Models 281/288

New fuel hose, new tank ventilation

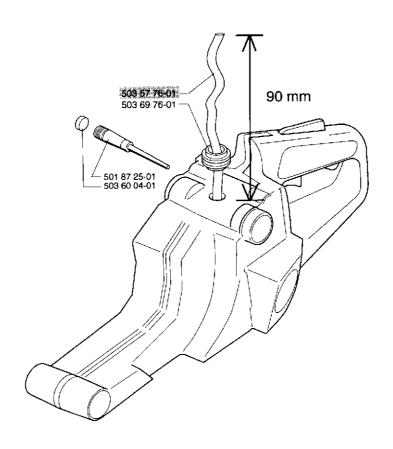
A helical shaped fuel hose is introduced in order to simplify the change of fuel filter. An improved tank ventilation is introduced at the same time.

Description	ExcL Ref. No. Remark
Fuel hose	501 42 65-02 R
Tank ventilation valve	501 62 96-01 R
Filter plug	
Grommet (crankcase)	501 55 10-01 R
	Fuel hose Tank ventilation valve Filter plug

NOTE! When mounting the new fuel hose, a 90 mm extended hose should be available at the outside.
